# MERCY OTHELLO PLAZA

DESIGN RECOMMENDATION MEETING - DPD# 3018112

**6940 MLK JR WAY S.**  
AFFORDABLE HOUSING

08.18.2015

RESPONSE TO EDG BOARD GUIDANCE: M L KING JR WAY S FRONTAGE - INVITING ACCESSIBLE ENTRY

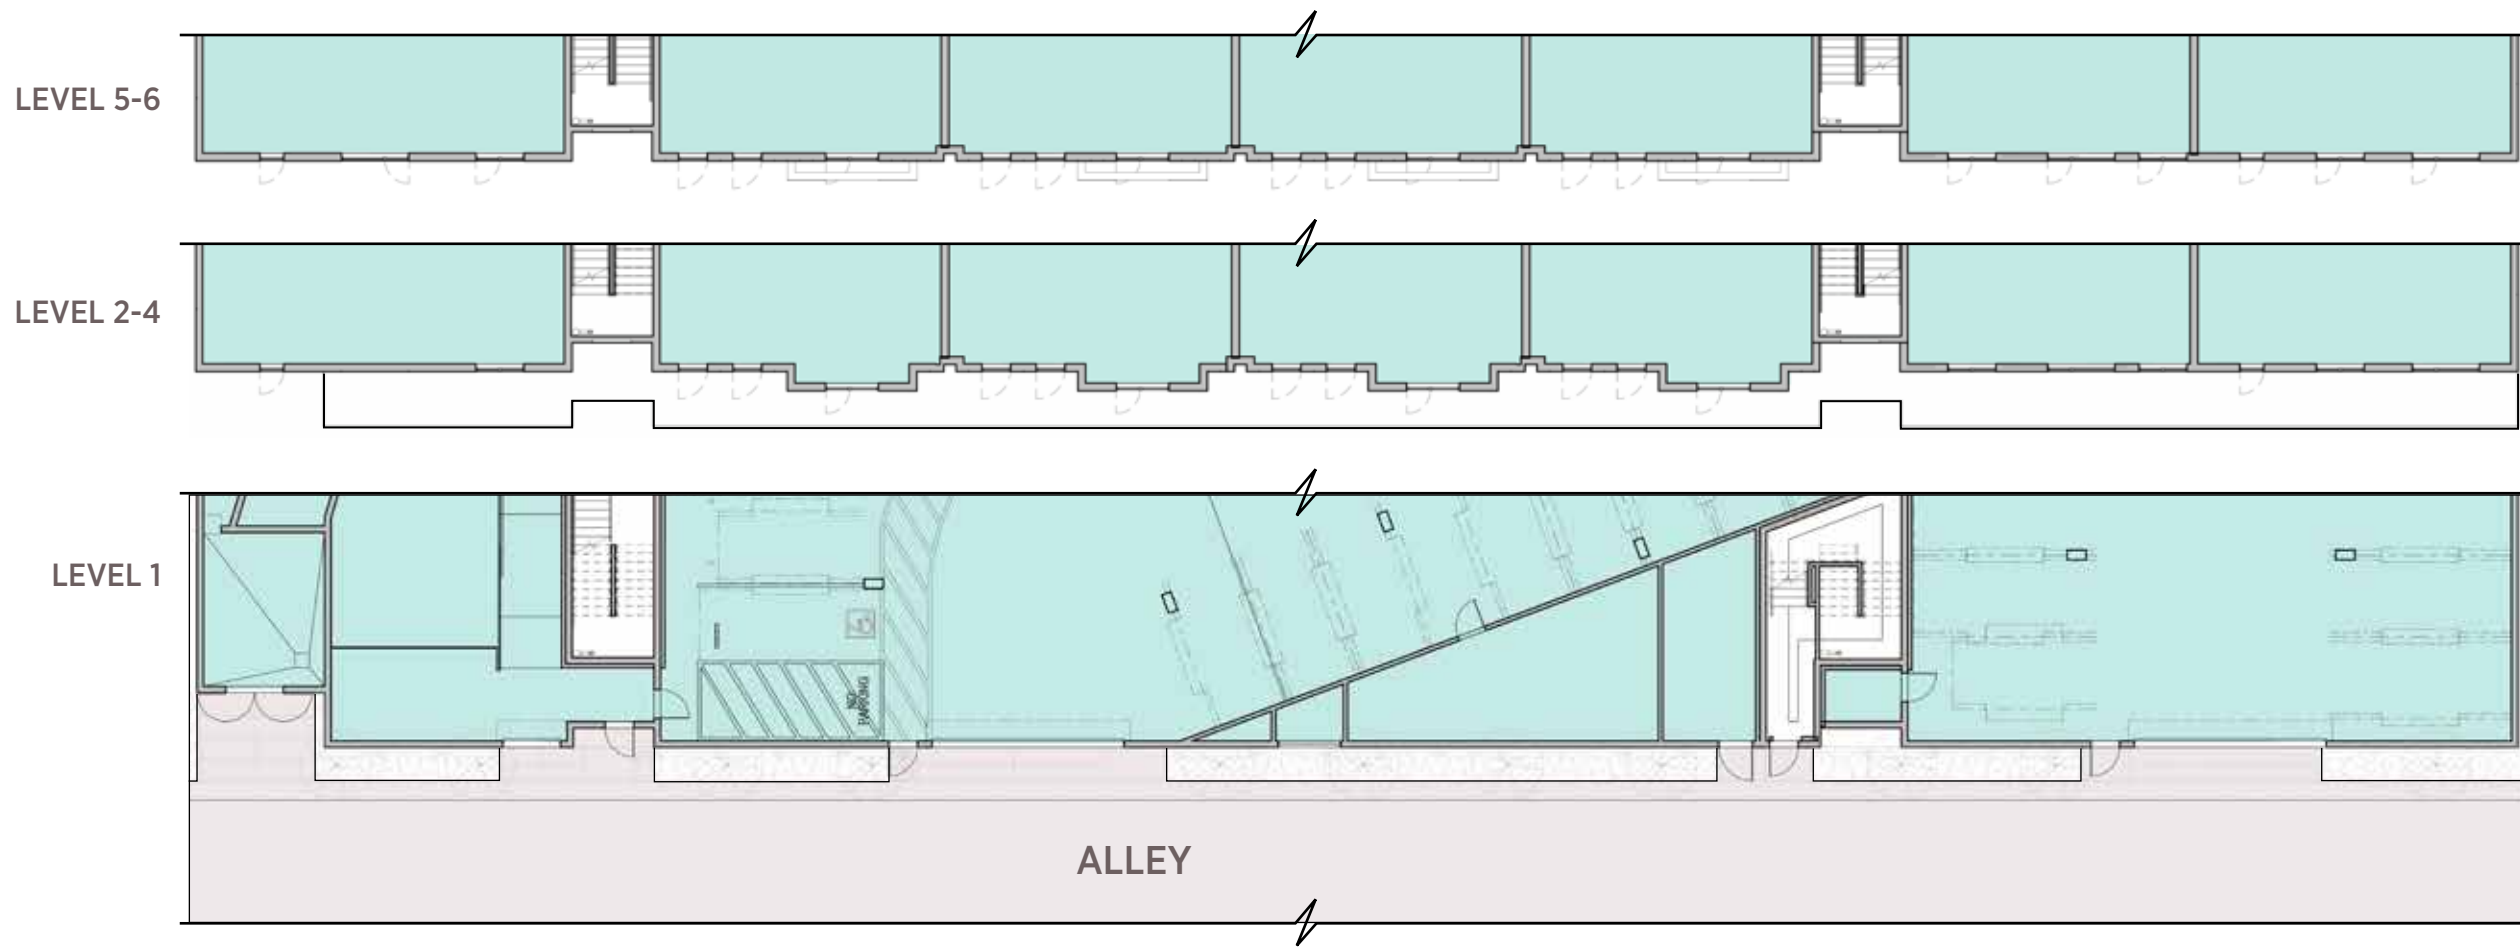
**RECOMMENDATION**

The Board stated that it is important that the main residential lobby entrance which may be utilized as a public entry be accessible and inviting. At the recommendation meeting, the board expect to review design elements that encourage interest at street-level and clarify building entries/edges.

**APPLICANT RESPONSE**

- Vertical forms frame one story entry
- Entry panels - texture
- Signage - wayfinding

EAST ELEVATION

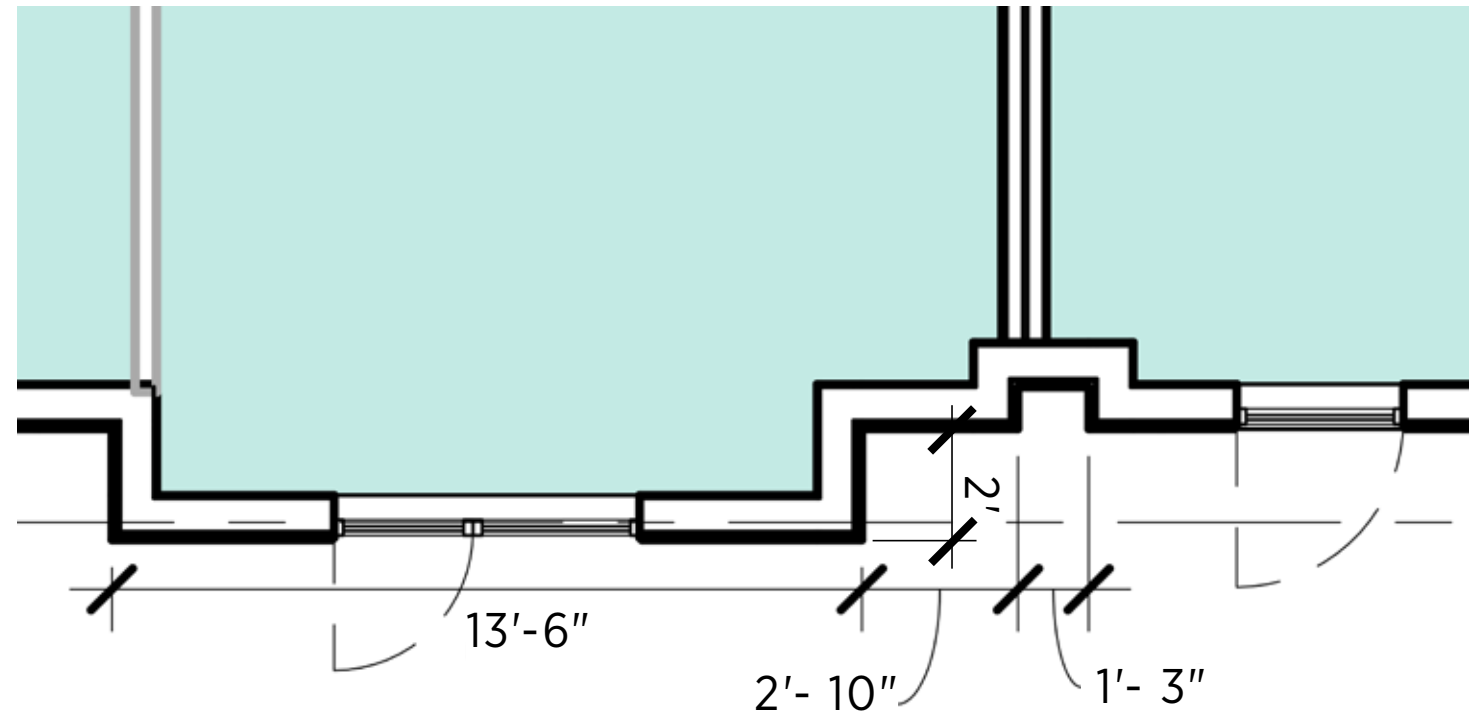
The board expects to review further development of the eastern facade that creates additional articulation, includes secondary architectural features, and contains two to three story elements that are broken down to an appropriate residential scale.

notches at stairwells continued at ground level to break down base

Recall of patterning along west facade ties together verticals and horizontals

concrete at ground level painted to match material above and visually bring massing to ground

2' deep bay windows break down length of facade and related to LR2 szone across the alley

Smaller recesses at demising walls divide up middle part into individual stacks of units.

### APPLICANT RESPONSE

- 20' below maximum 65' height
- 3 separate forms and base
  - Recesses
  - Color
- Upper setback 11' from property line
- Individual 3-story projecting bays

- Bays sized to emulate scale of anticipated east alley future development
- Secondary
  - Color - light bounce with non gloss
  - Window difference
  - Siding orientation
  - Base texture

- Landscape - Greenscreen
  - Texture
  - Color
- Lighting
  - Safety

RESPONSE TO EDG BOARD GUIDANCE: PUBLIC & RESIDENTIAL OPEN SPACES - COORDINATION WITH SOUND TRANSIT SITE DESIGN

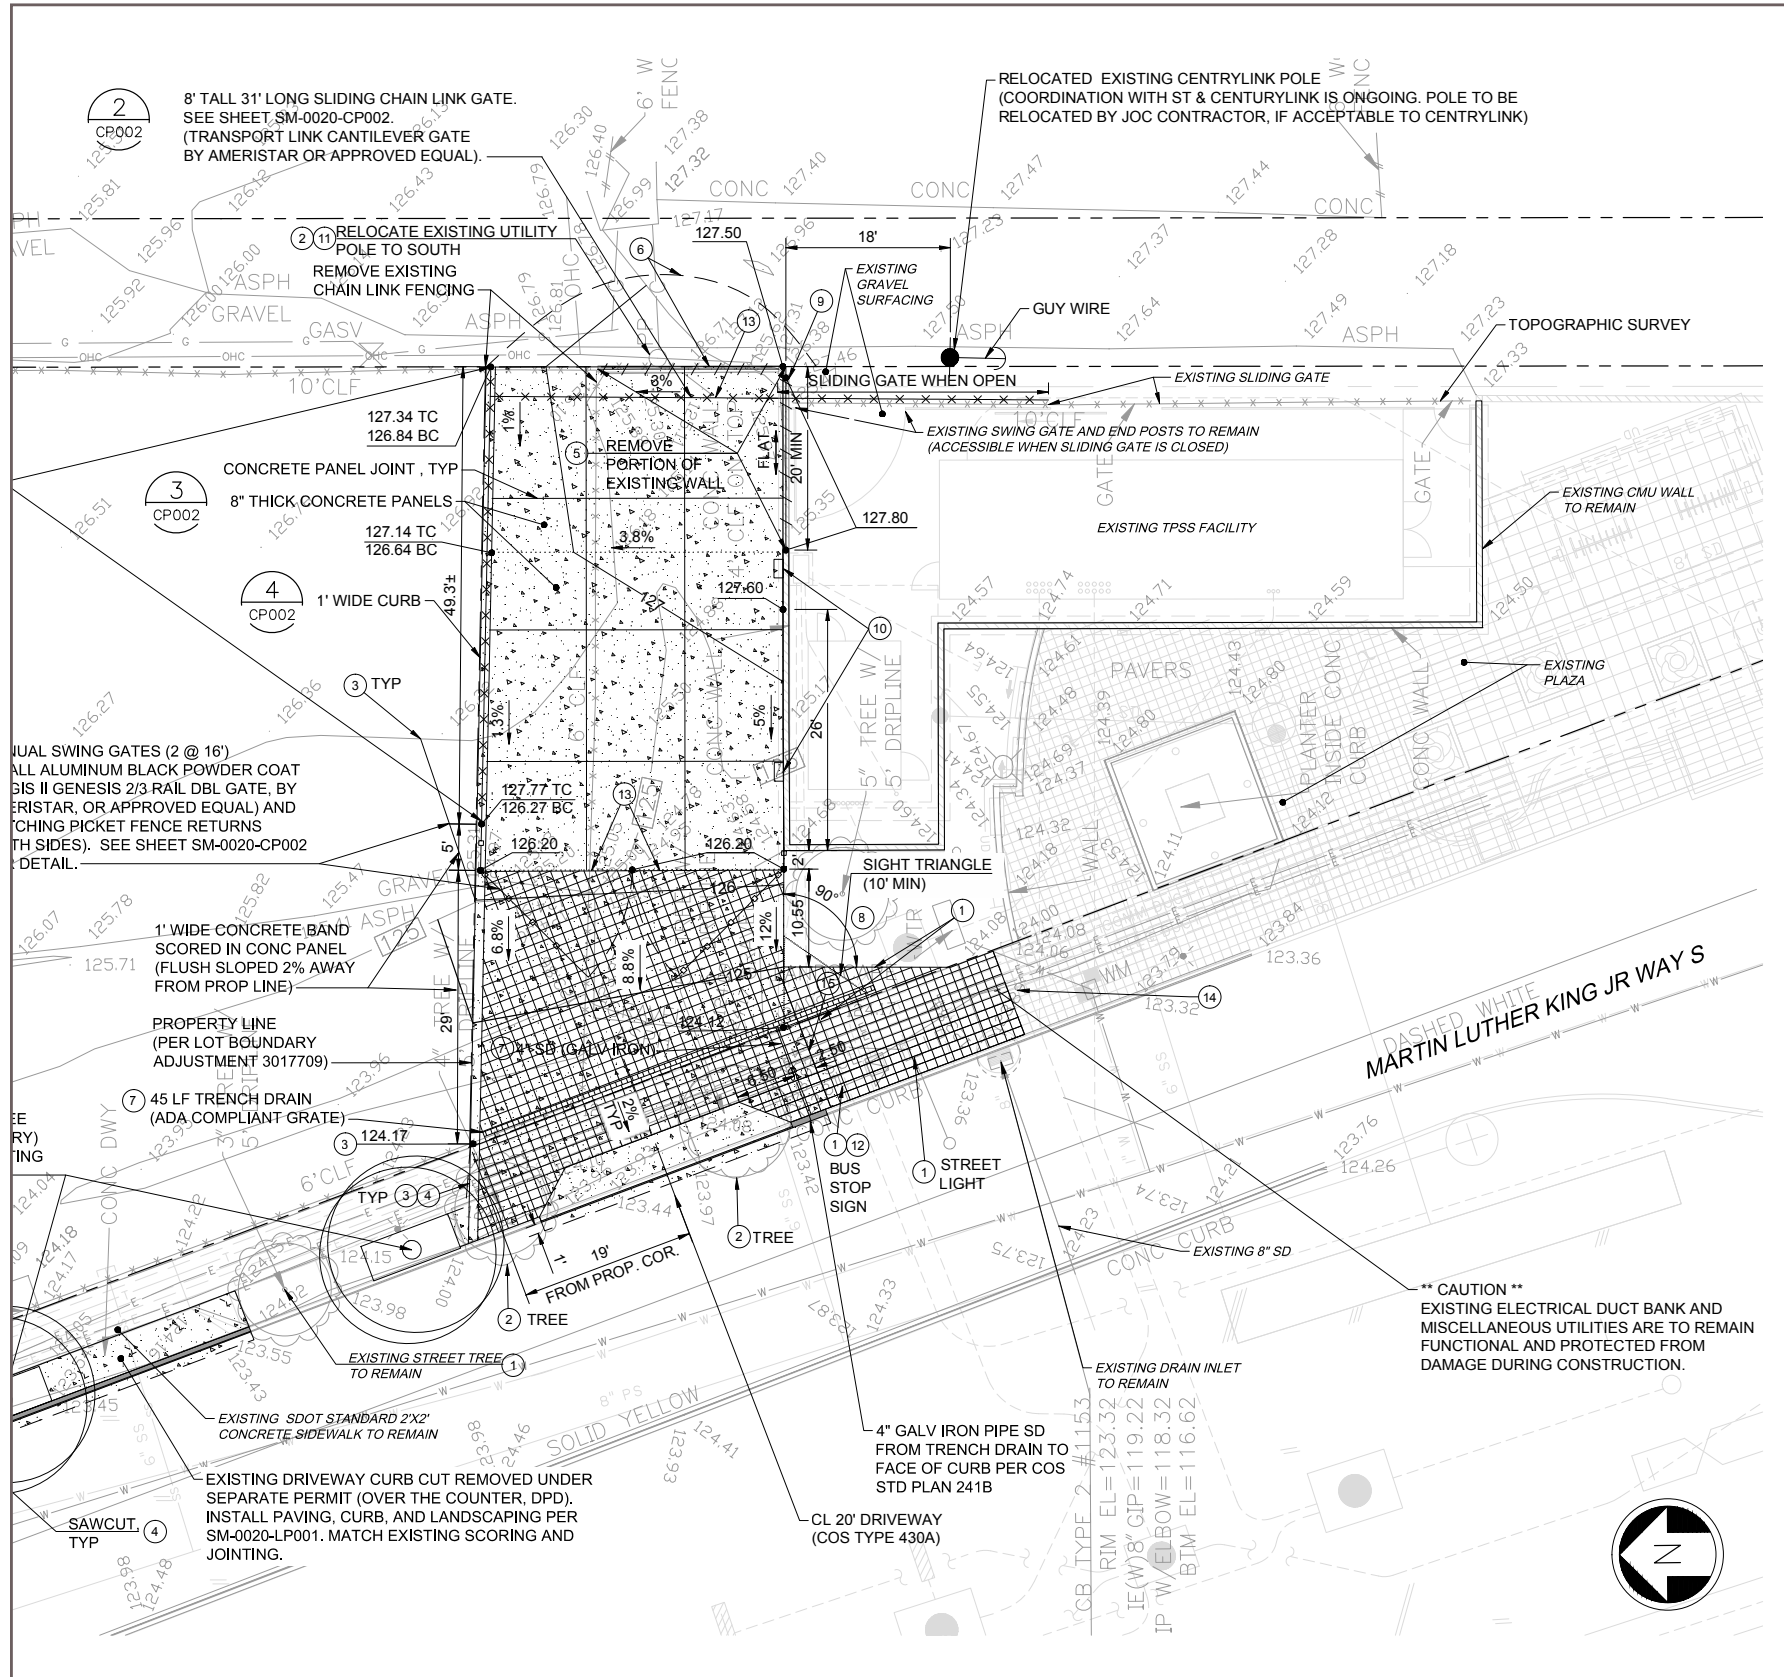
It is important that the Board understands the relationship between the project's plaza design concept and possible improvements at the Sound Transit property which may result in a larger plaza area

APPLICANT RESPONSE

- South facing entry plaza
- Connection to bus transit
- Replicating sound transit ground pattern creates one plaza
- Landscaping unites plazas

Scoring patterns to match adjacent site

RESPONSE TO EDG BOARD GUIDANCE: PUBLIC AND RESIDENTIAL OPEN SPACES - ACCESS TO COMMUNITY ROOM

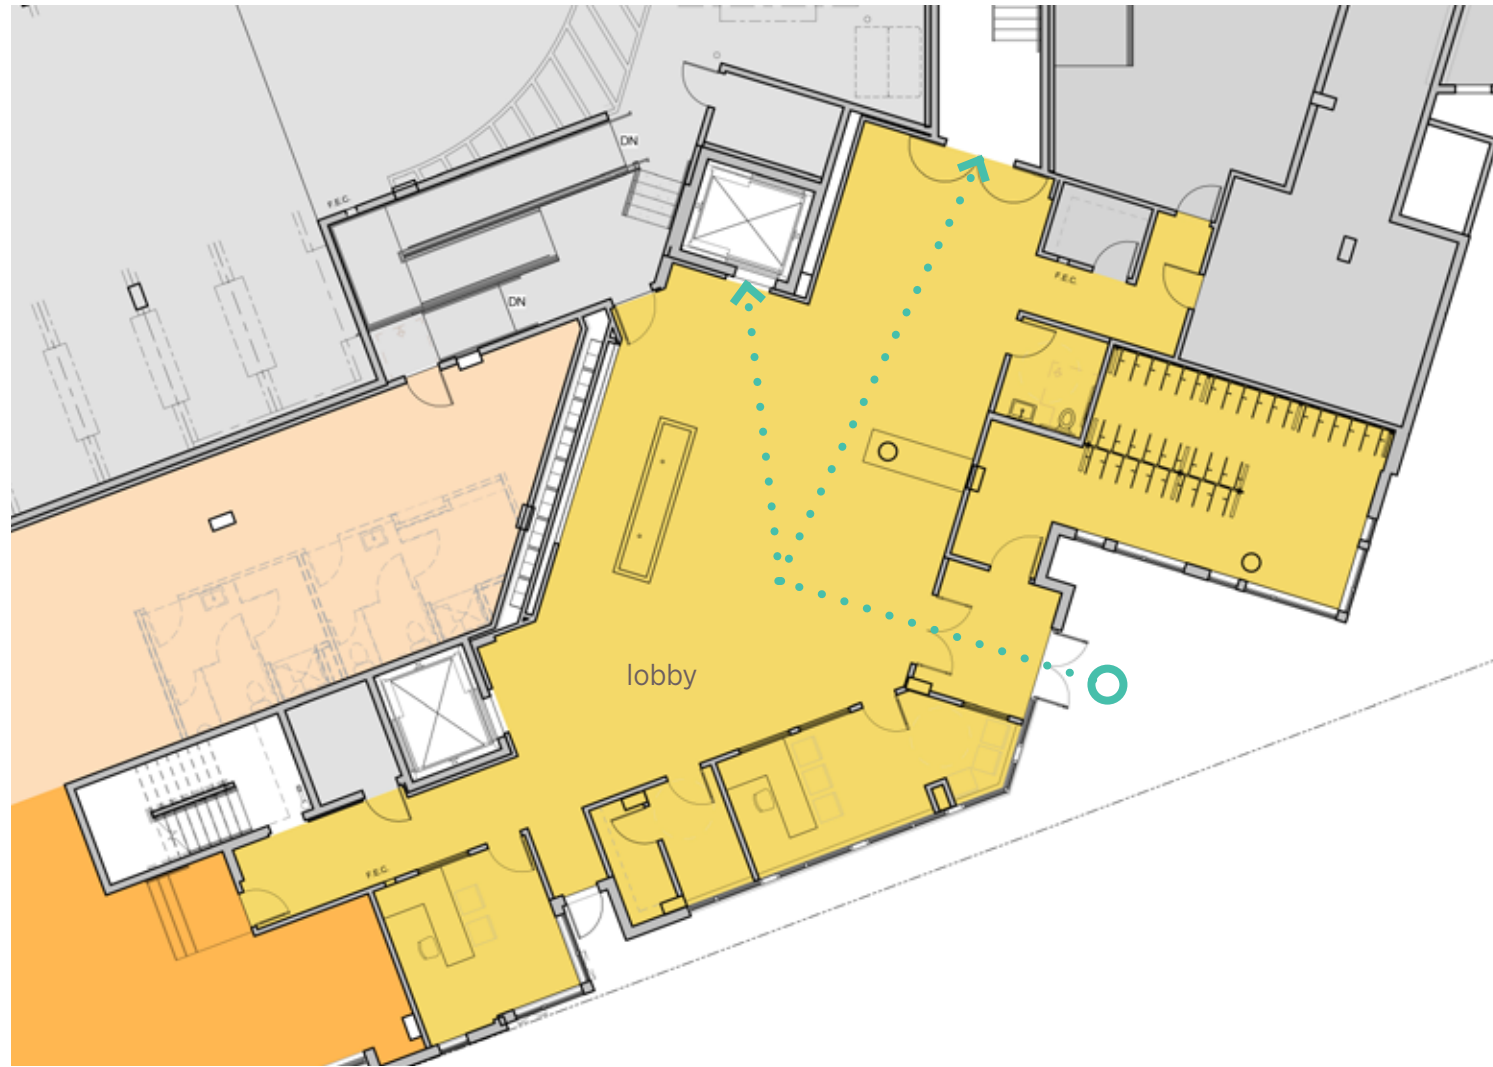
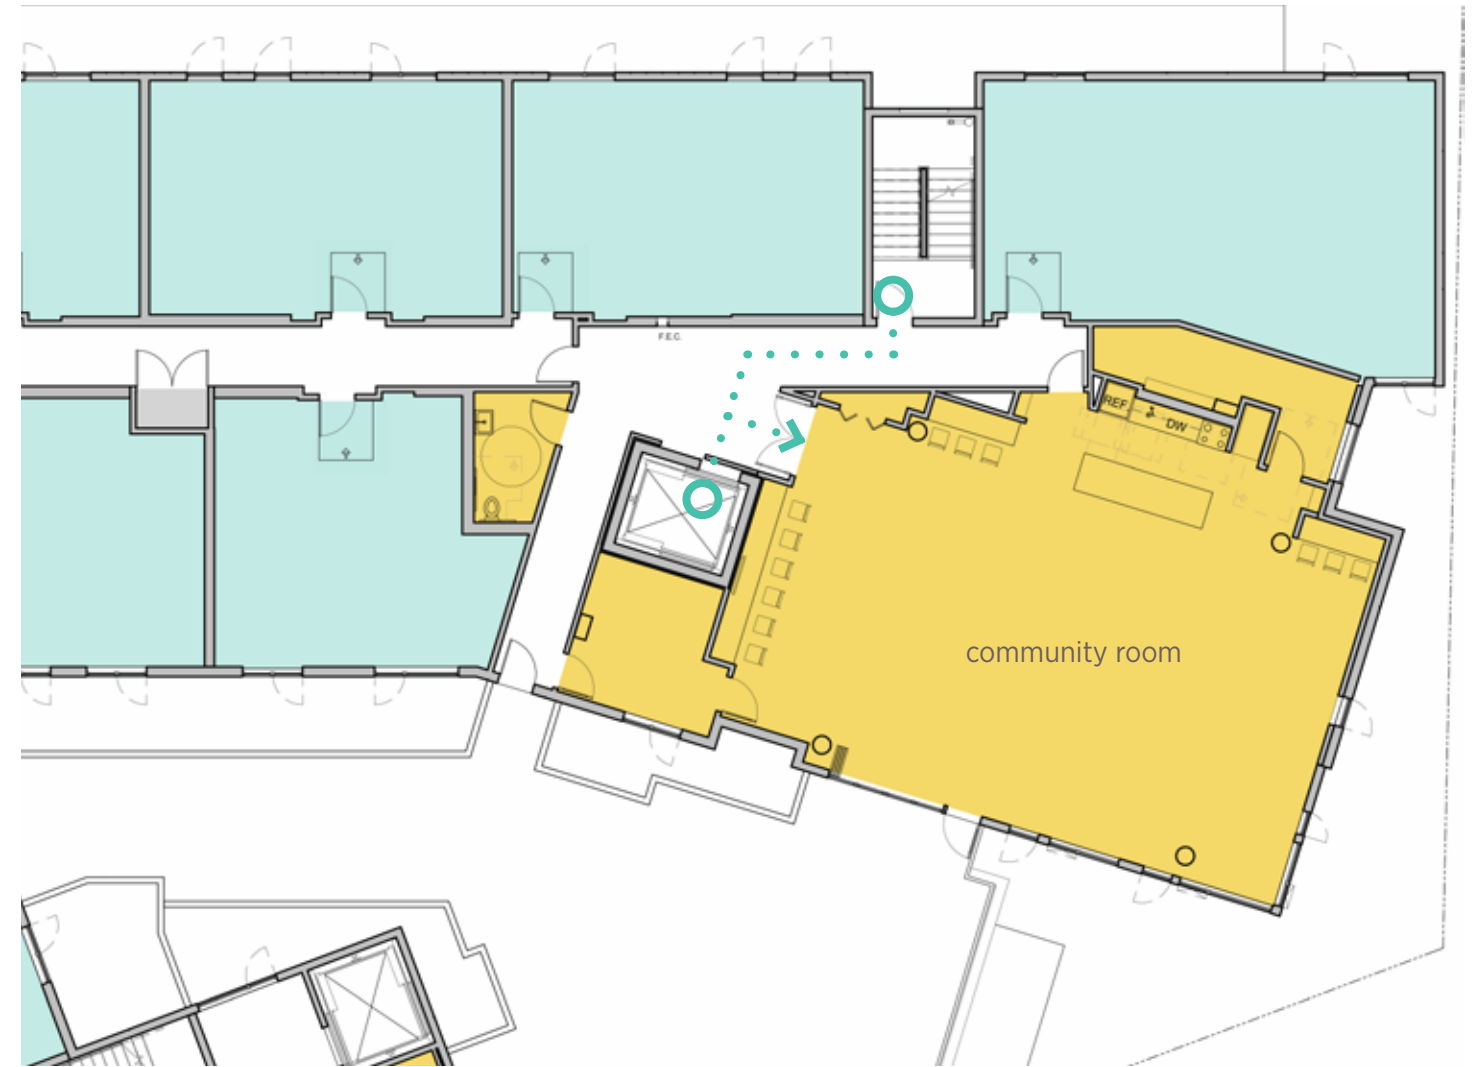
RECOMMENDATION

The Board expects a diagrammatic, programmatic demonstration on the circulation flow for public access to the community room and clarity on the delineation of public and private areas.

APPLICANT RESPONSE:

- Upon entry - direct line of sight
  - Elevator
  - "Grand" stair
- "Grand" stair on hold opens
- Scheduled events in community room and courtyard
- Door between private units and community room

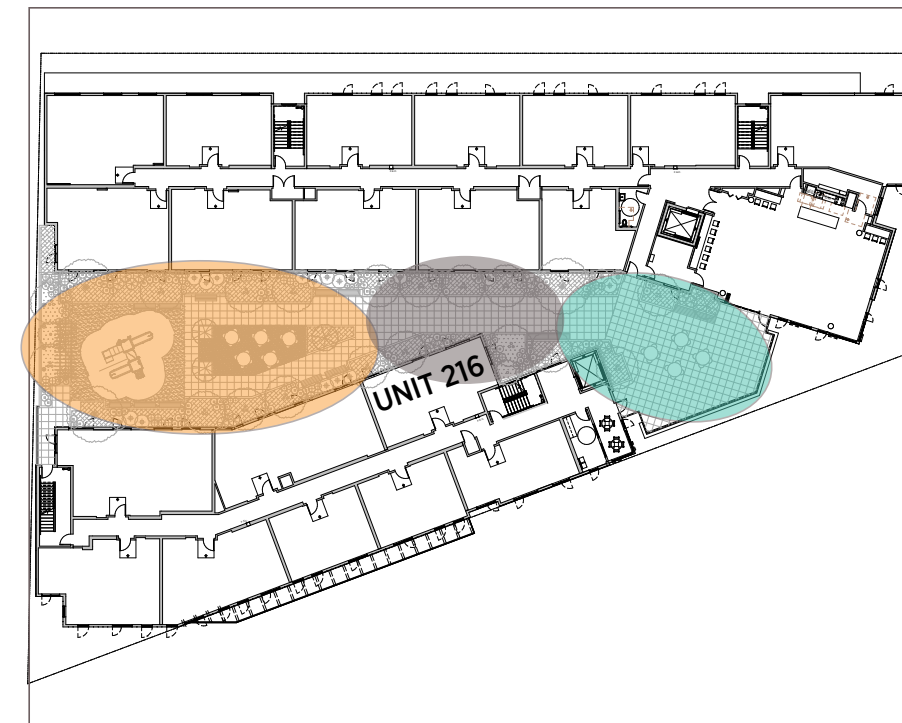
**RECOMMENDATION**

The Board identified areas between the proposed upper residential linear bar building masses that appeared to be narrow in width and commented that this need further exploration. The board requested information regarding the spacing daylight and shading impacts to the courtyard and residential units, and a better understanding of how the upper buildings will interact with one another be presented to the Board at the Recommendation meeting.

**APPLICANT RESPONSE**

- Neck separates communal from private (17 to 30 feet at unit 216)
- West circulation area at neck
- Open both ends - light and air
- Courtyard - light color - reflectivity
